**SUBJECT: NEW VEHICLE DEMONSTRATION / DELIVERY HOLD - Safety Recall 17S23**  
Certain 2017 Explorer, Taurus, Police Interceptor Utility and Sedan Vehicles  
Electronic Power Assist Steering Heat Shield Fastener Inspection

**NEW VEHICLE DEMONSTRATION / DELIVERY HOLD - Safety Recall 17S23**

## CERTAIN 2017 EXPLORER, TAURUS, POLICE INTERCEPTOR UTILITY AND SEDAN VEHICLES — ELECTRONIC POWER ASSIST STEERING HEAT SHIELD FASTENER INSPECTION

**FIGURE 1**

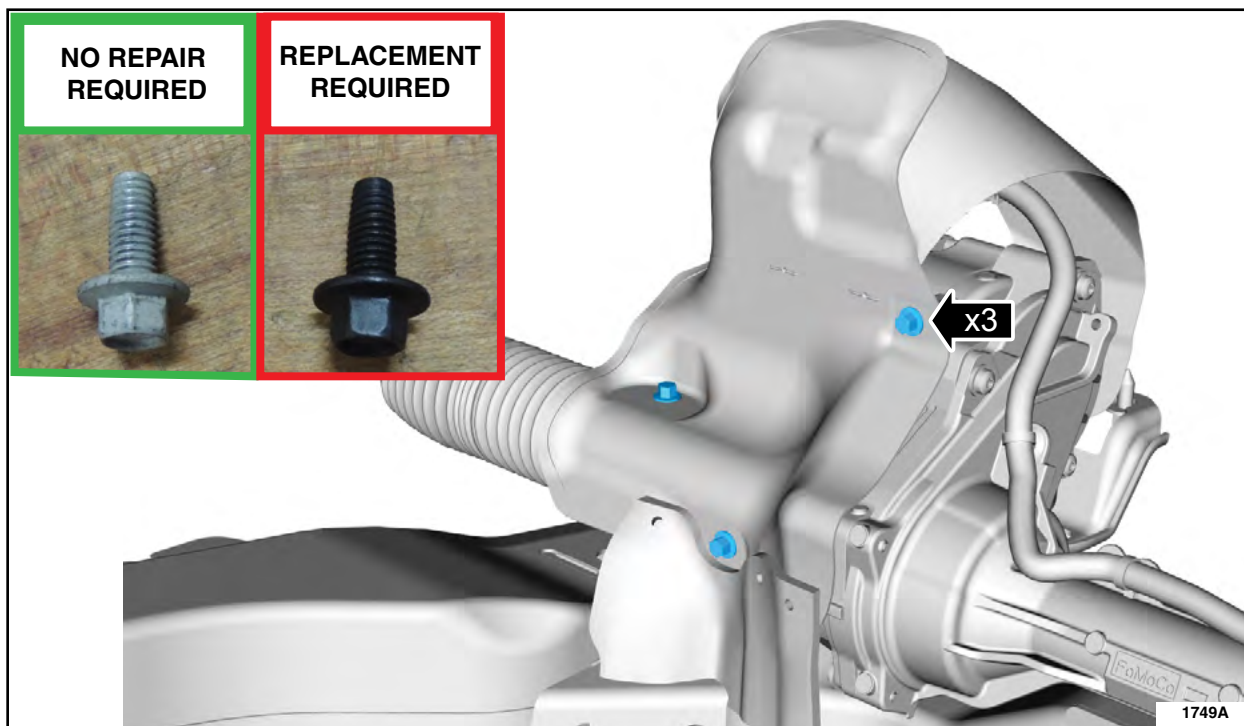
In some of the affected vehicles, the fasteners used to secure the Electronic Power Assist Steering (EPAS) heat shield may not have sufficient corrosion protection. If the fasteners do not have sufficient corrosion protection, they may not retain the heat shield over time, exposing the steering gear to higher than expected temperatures. If the steering gear connectors melt, the driver may experience loss of assist accompanied by the fault message “SERVICE POWER STEERING NOW” in the instrument cluster. Loss of power steering assist while driving would result in higher steering efforts, especially at lower speeds. Dealers are to inspect and replace, if necessary, the EPAS heat shield fasteners following the Service Procedure below.

2. Inspect all three steering gear heat shield fasteners. Are all three fasteners gray in color?  
See Figure 1.

3. If equipped, remove the under body shield retainers and the under body shield.
4. Replace each of the three highlighted fasteners that are not gray in color. See Figure 1.

- Tighten the *new* steering gear heat shield fasteners to 9 Nm (80 lb-in).
